Application by Mallard Pass Solar Farm Limited for an Order Granting Development Consent for Mallard Pass Solar Project- EN010127

Submission by John Hughes: ID ref: 20036141

Deadline 2 Written Representation: Substation (APP- 125) & ZTV Figure 6.6 (APP-138), Representative View Points 1 – 20, APP-140 to APP-159, Photomontages A – E, APP 168 to APP – 172,

If you zoom into VP11 on the ZTV Figure 6.6 (APP-138) Glen Crescent and the The Bungalows along Stamford road they are not effected by any of the proposed structures, how can this be correct when the current substation can be seen from within the house, garden or footpath along the A6121.

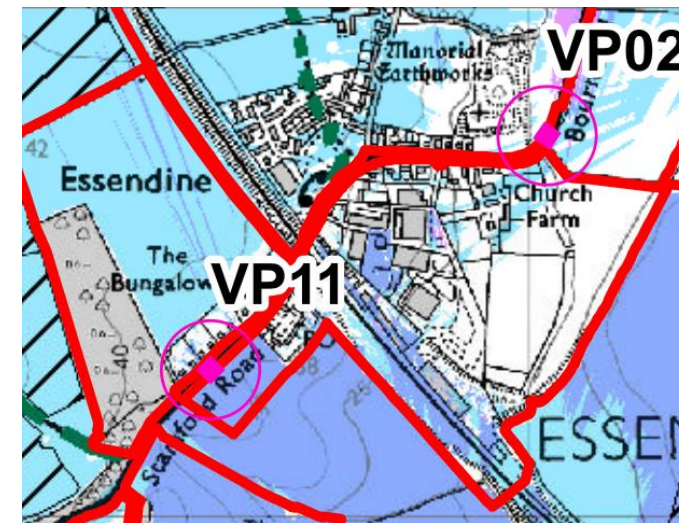
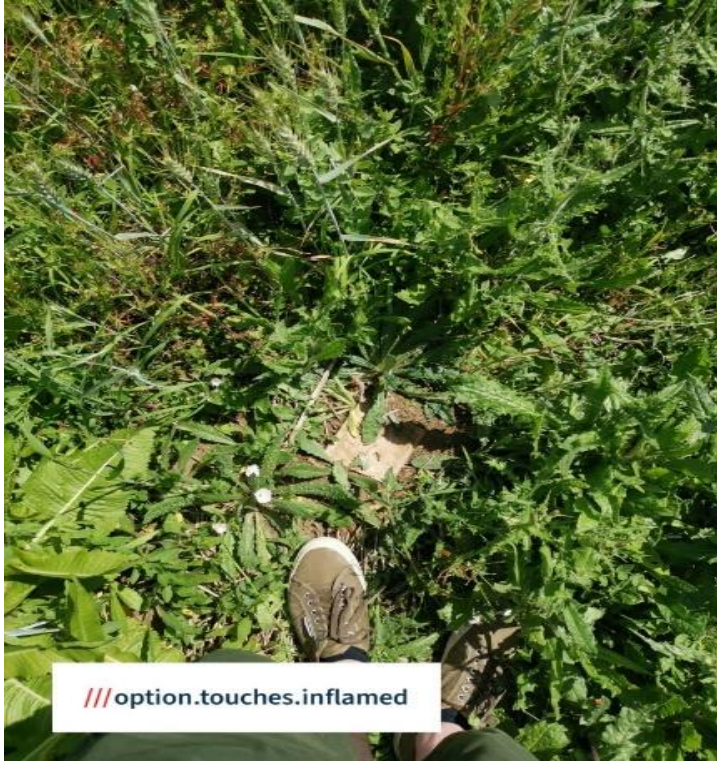
Q. Why was the drone marker placed in the field behind Glen Crescent (option.touches.inflamed) not used in the presentation of the project as a VP when it would have given a clearer photograph and photomontage representation of both the current and proposed new substation and PV arrays?

Viewpoint 1 APP-140 & APP-168 Carlby Road

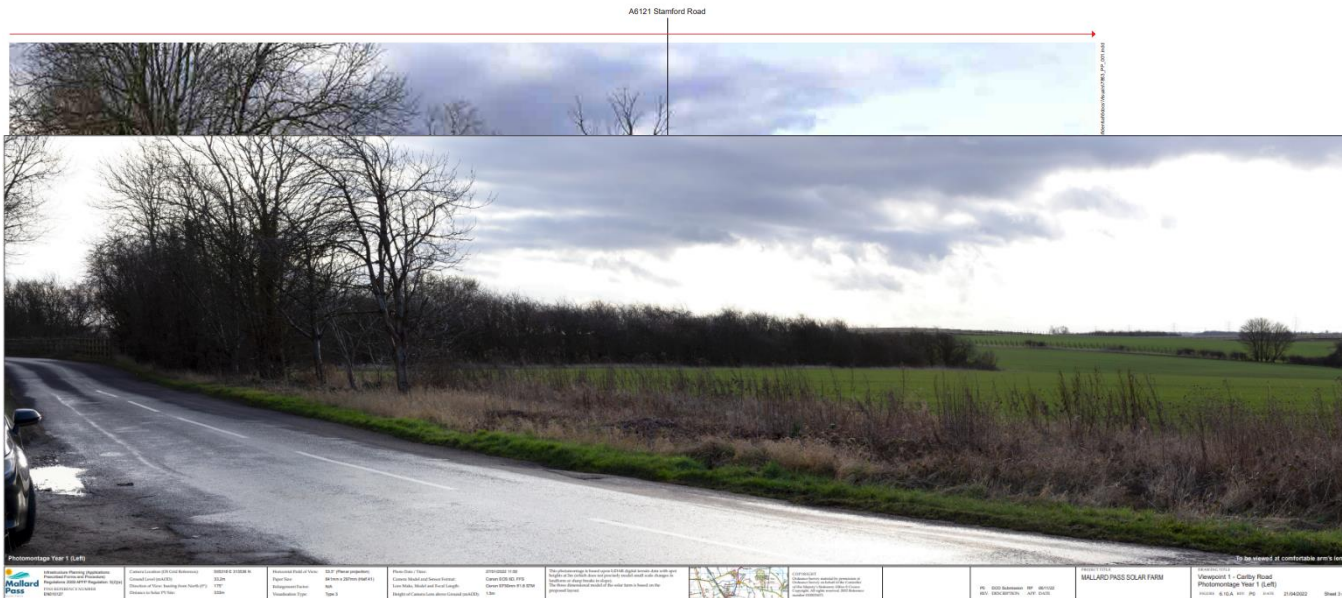
Is representative of motorist just meters from a road junction, the location does not represent the view from a footpath, bridleway, property or village with the field in the fore ground not part of the proposed project and over 2km away from the proposed substation. The dense shrubbery on the left viewpoint hides the openness beyond the old railway line. This VP has been used for a photomontage to represent the visual impact for the proposed substation to which there is minimal detail and PV arrays, motorist will not have time to judge this view point as they will be concentrating on negotiating the road junction. The VP is representative of motorist and not honest of what is being proposed and its visual impact.

Q. What is the purpose of the Location and what is the photomontage trying to present as it's not in a village or on a footpath?

Q. What's the representation of the solar array like on the clear spring, summer, autumn day with blue sky and higher natural light levels?

Q. What guarantees what is represented in the photomontage will be achieved, what will be done if it's not and who would be responsible?

Representative Viewpoint 2 (Left) - A6121 Bourne Road to the east of Essendine village

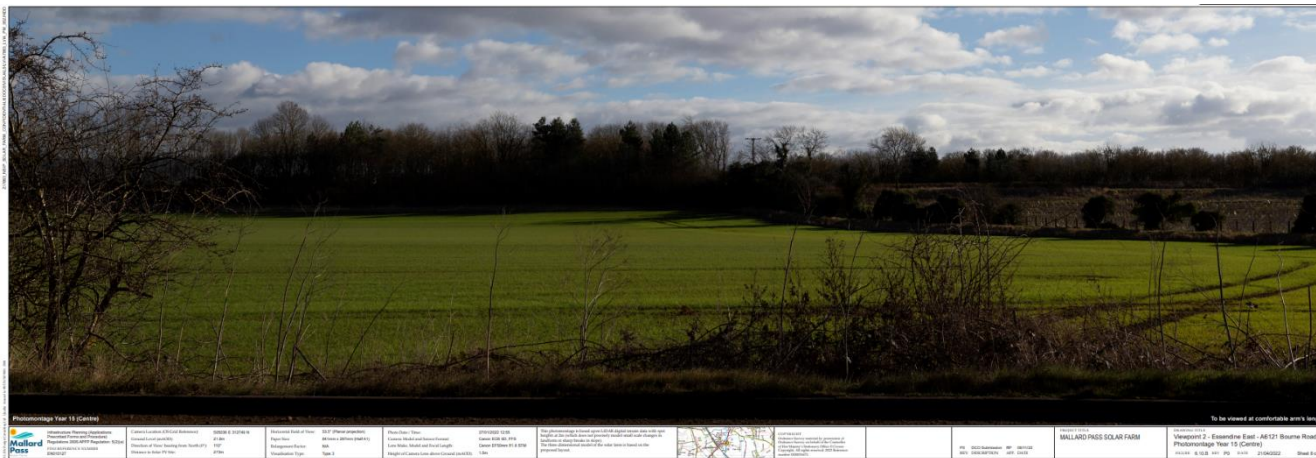
The VP is at the lowest point of the village of Essendine at 22m by the river and representative of motorist and pedestrians, inclines toward the bank of the disused railway line, buildings in the Industrial estate or the bank of the ECML impede the view. The VP should have been taken from a higher point such as the footpath between Essendine and Carlby or the gate on Manor Farm lane.

Photomontage Year 15 (left) 50% of the horizon is obscured by bushes in the foreground with the visual impact of the Solar Arrays distorted because of it being the low point in the village. MPSF have used the topography and VP location to mitigate the Visual impact in their favour. Even if cumulative wire line drawings were used at this location they would not highlight the visual Impact/size of the Solar Farm.

Photomontage Year 15 (centre) The Visual impact of the Solar Arrays is distorted because of the VP being at a low point. MPSF have used the topography and VP location to mitigate the Visual impact in their favour as cumulative wire line drawings would not highlight the visual impact/size of the Solar Farm.

Photomontage Year 15 (right) The visual impact of the Solar Arrays are not apparent as you are looking up towards the old disused railway line but also the current embanked section of the ECML. MPSF have used the topography and VP location to mitigate the Visual impact in their favour as cumulative wire line drawings would not highlight the size of the Solar Farm new structures.

Q. What determined the location and selection of this view point as it is on the very edge of the village and at one of the lowest points on the site with all elevation rising up?

Q. Why was this VP selected to be used as a photomontage?

Representative Viewpoint 7 (Centre) - Public footpath Uffi/5/1 to east of Newstead Lane and Cobbs Nook Farm

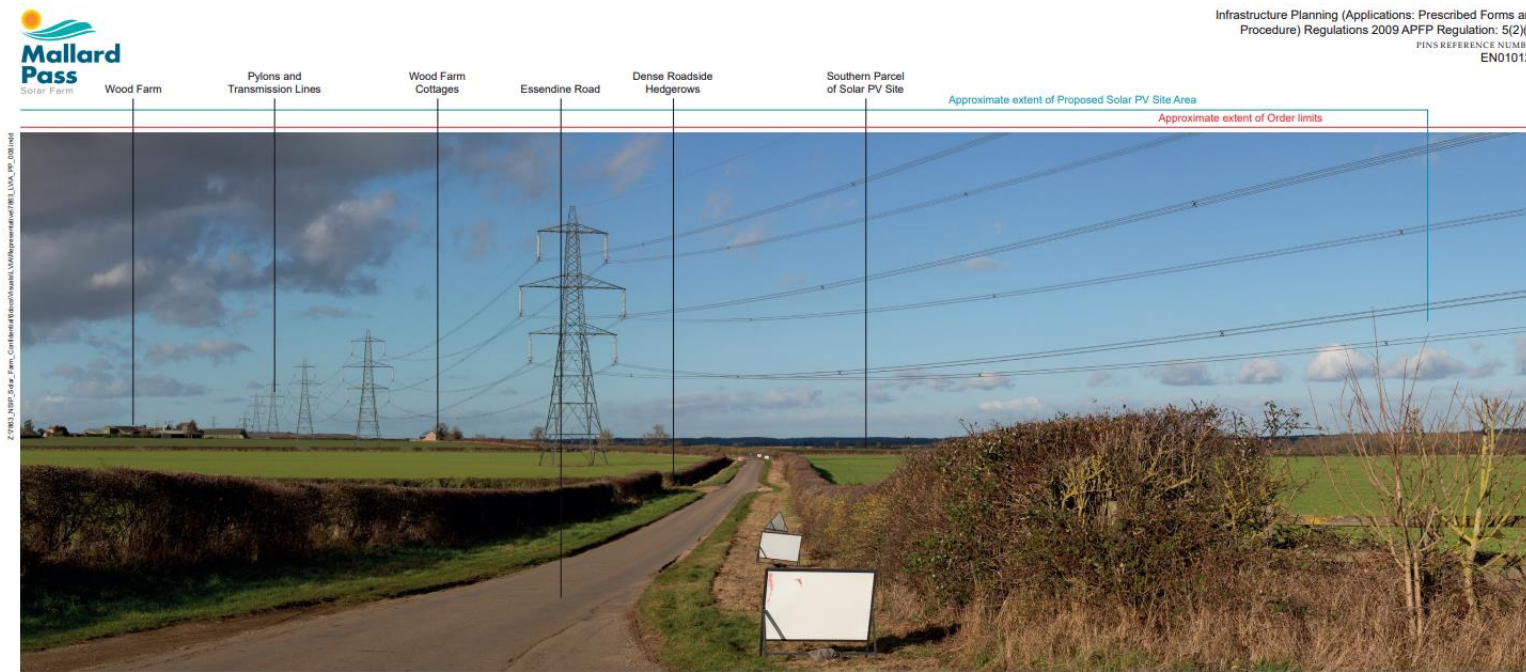
These photos are more representative of the current views and better located than the Stage 2 photo which were at a lower point.

Photomontages should be presented so examiners can appreciate the effect the mitigated planting and PV arrays will have to walkers of this footpath.

Representative Viewpoint 9 (Left) - Essedine Road near The Freewards

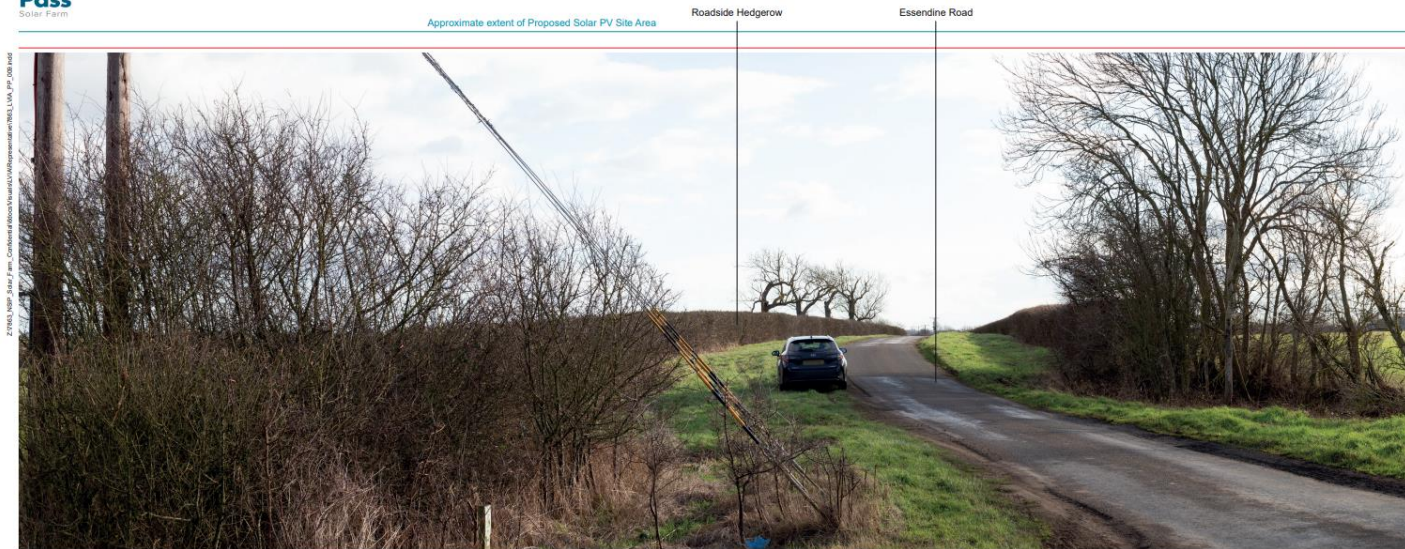
The VP is representative of motorist and the closest VP to the proposed new substation and taken at a low point in the road.

Note Essedine Industrial Estate on the left but no indication of the location of the new substation in either photo because it is so far right.

Note the distant fields on the opposite side of the ECML and how they reach the horizon these will filled with PV array.

Representative Viewpoint 11 (Left) - A6121 Stamford Road on the south-west approach to Essendine

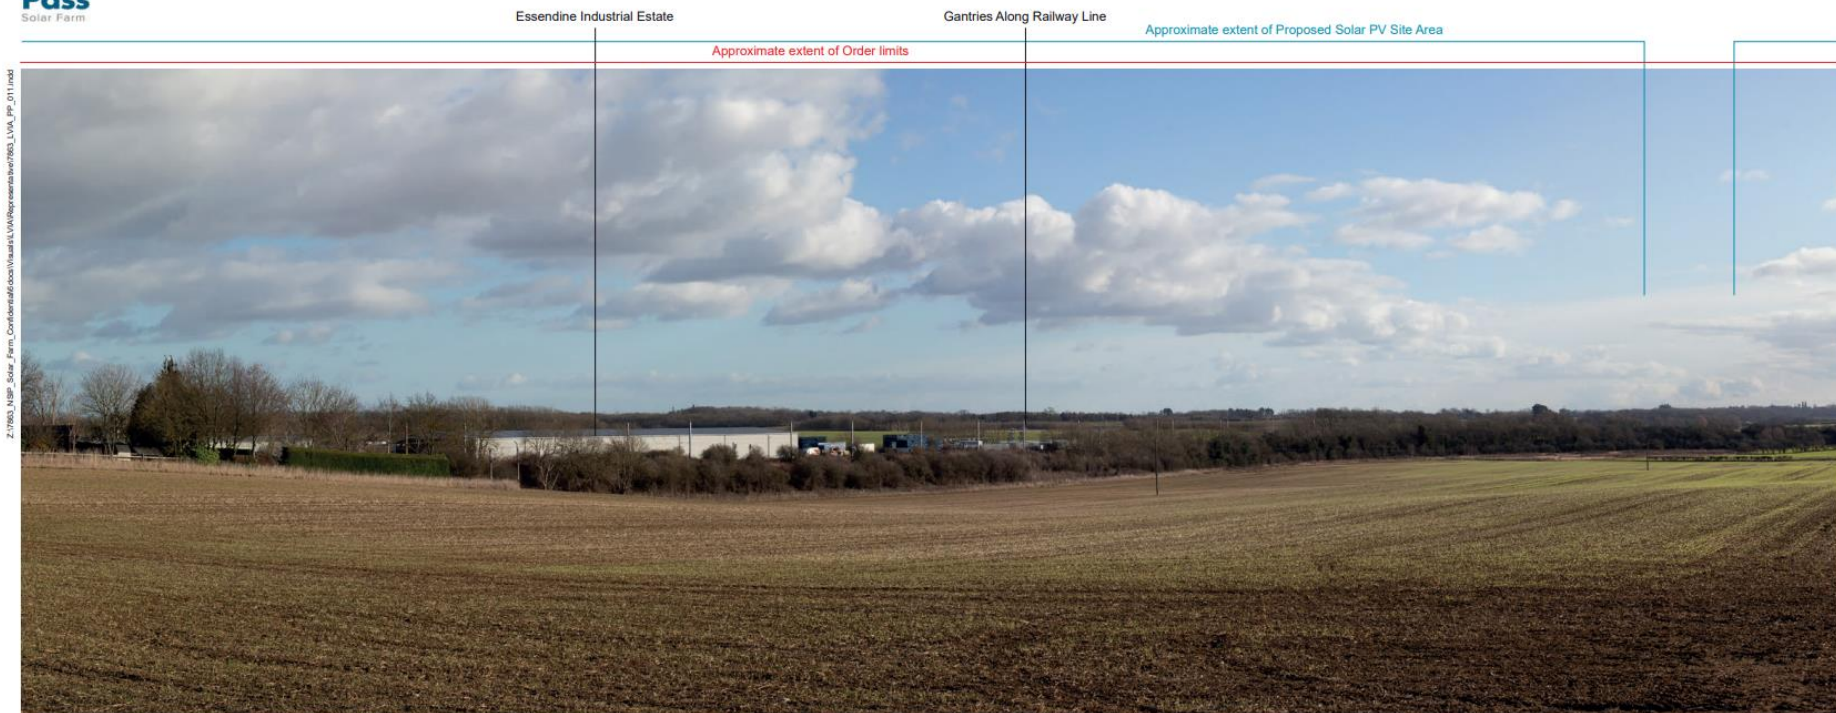
This VP is representative of walkers and motorists on the A6121, the location conveniently uses Freewards wood to hide the Ryhall 400kV substation which is visible today.

Q. Why is the scale of effect only medium (adverse) Yr1 to small (adverse) Yr 15 when screen planting will not mitigate the effect while VP12 is large(adverse) Yr1 to medium (adverse) Yr15

Q. Where is the representation from a residents point of view in Glen Crescent or The Bungalows from their lounge or garden?

The PV arrays and new Primary Substation and buildings would have a major impact on the landscape and visual horizon, there are no current structures present with the visual impact of the photomontages lessened because of the time of year the photo was taken.

Q. What would be the visual impact in Spring, Summer, Autumn with the changing colours of the seasons, higher light levels and the sun setting further west with light reflecting of the proposed structures as well as a night with regards to operational lighting.

Q. What's the visual impact from the perspective of a Cumulative wire line drawing?
